DOCUMENT NO	REVISION	DATE OF REVISION
P-WGP2-055	Rev 1	22/05/2020

WAITSIA GAS PROJECT STAGE 2: WATER MANAGEMENT PLAN

Document Title:		Waitsia Gas Project Stage 2: Water Management Plan	
Revision Number:		Rev 0	
Review Date:		30 January 2020	
Item No.	EMP Section No.	DWER Comments	Proponent Response (Rev 1 update)

Figure 2-1 Mean rainfall for Mingenew (station 008088, source: BOM)

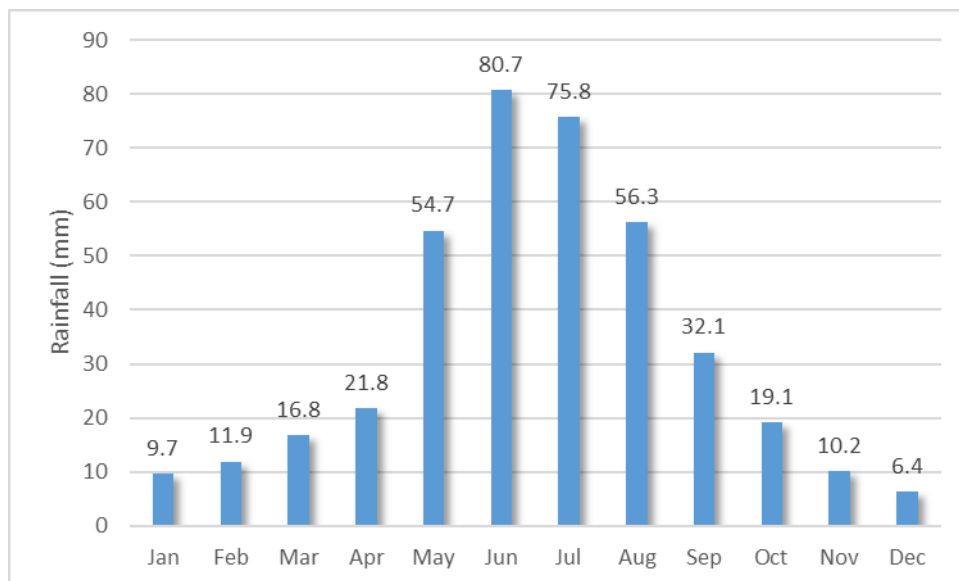
2.	Figure 2-1 of Appendix 1	<p>Rainfall assessment data used are from the BOM Mingenew site approximately 50 km from the project site. BOM rainfall data is available for Dongara close to the site.</p> <p>DWER recommends this section is updated using rainfall assessment data from the Dongara BOM site, or justification is provided for why the alternative Mingenew BOM site was used.</p>	<p>A review of the Dongara weather station rainfall data identified gaps in the data set (33 months missing since 1999), and a large proportion of the data was reported as not quality controlled (2012-2014).</p> <p>A comparison between the BoM rainfall data at the Dongara and Mingenew weather stations identified that the mean annual rainfall for Mingenew and Dongara stations is 402 and 454 mm/annum, respectively (rainfall at Mingenew is 88% of that which falls at Dongara. i.e. similar amount). A review of the annual median rainfall data found that the Mingenew rainfall was 92% of that at Dongara.</p> <p>The rainfall data from the BoM Mingenew station was selected for the following reasons:</p> <ol style="list-style-type: none"> 1. Gaps in the data set and questions over the quality of the data at the Dongara weather station. 2. The Mingenew and Dongara weather stations experiencing similar rainfall amounts and rainfall distribution throughout the year. <p>The outcome of the groundwater modelling in terms of relative drawdown in groundwater levels attributed to the proposed abstraction associated with the Waitsia Gas Plant is not considered to be sensitive to a change in the rainfall amount. In addition the calibration of the model achieved water levels close to measured water levels (modelled levels 0.15 – 0.25 m lower than measured levels) at monitoring bore W02 (closest to the proposed Gas Plant).</p>

Figure 3-4 Example model section (W-E) across the Project Site and Ejarno Spring

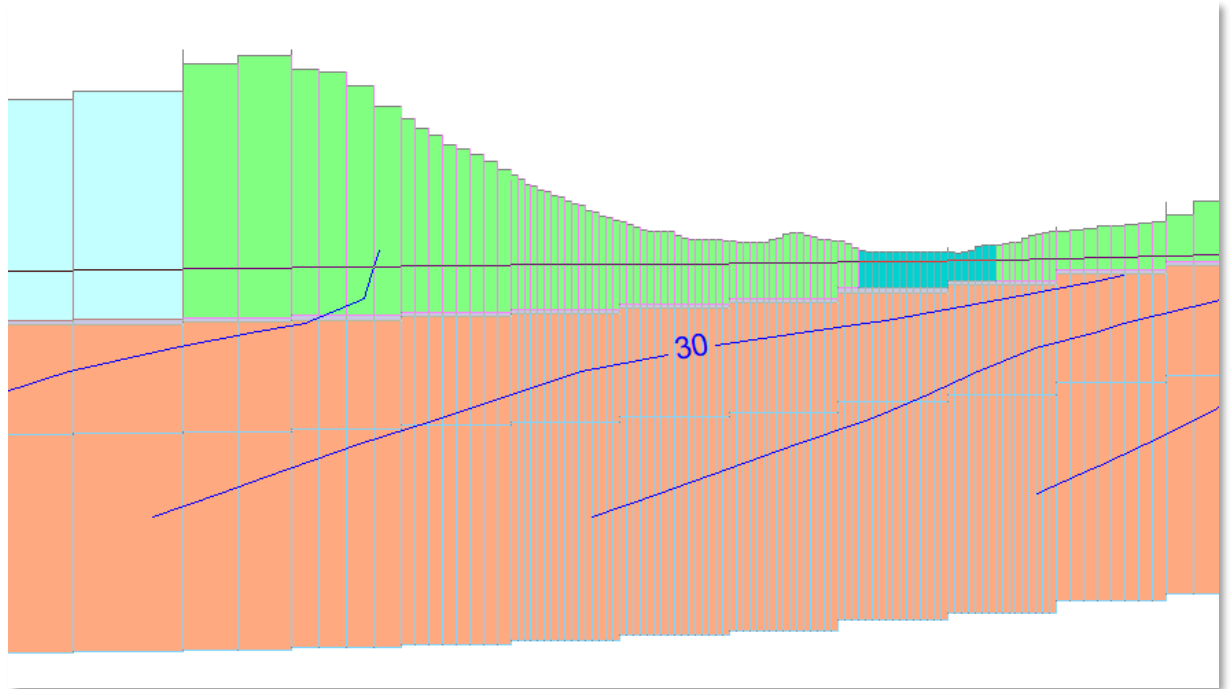
1.	Figure 3-4	<p>The Yarragadee formation structure is not represented correctly. The hydrogeology of Ejarno Spring is drawn from Rutherford 2005 which is incorrect in its portrayal of “slab” like Guildford Clay instead of an easterly thinning unit, wedging out at the foot of the Gingin Scarp. The presence of the Yoganup Sand was also omitted. The superficial sediments will overlie the Yarragadee Formation but not in the configuration as shown in Figure 3-4 of the plan.</p> <p>Figure 3-4 should be amended to accurately reflect the true configuration of the Yarragadee formation structure.</p>	<p>Figure 3-4 does not represent how groundwater modelling considered the presence of the Guilford Formation. All analysis and modelling were based upon available public sources and MEPAU is not aware of any drilling investigation work at Ejarno Spring that would provide further detail. To manage the data gap in local hydrogeological conditions, conservatism was applied within the groundwater modelling by NOT considering the low permeability Guildford Formation in the base case model, i.e. assuming interaction between the spring area and the aquifer system underneath that is not restricted by the clay layer(s).</p> <p>The hydraulic properties of the material in the Ejarno Spring area represented in the base case groundwater model are identical to the sandy ‘Alluvium’ unit as shown in Figure 2-3 of Appendix 1, with hydraulic conductivity applicable to sandy rather than clayey deposits that would have been expected if indeed Guildford Formation was present there.</p> <p>Recognising the potential presence of a clay layer, a sensitivity run (3) (page 21, “Lacustrine low K case” was conducted to assess its potential impact.</p> <p>Given that this was provided purely for visual representation and was sourced from Rutherford – MEPAU have removed Figure 3-4 from the Management Plan and further text to align with DWER comments:</p> <p><i>The nearest GDE, Ejarno Spring, is located approximately 500 m to the east of the WGP boundary. Ejarno Spring is associated with a topographic depression. The topographic depression suggests that the spring discharges into a system that may be perched, like those described west of Eneabba (Kern, 1997). Such a perched system would not be significantly impacted by small changes in groundwater levels in the Yarragadee.</i></p>
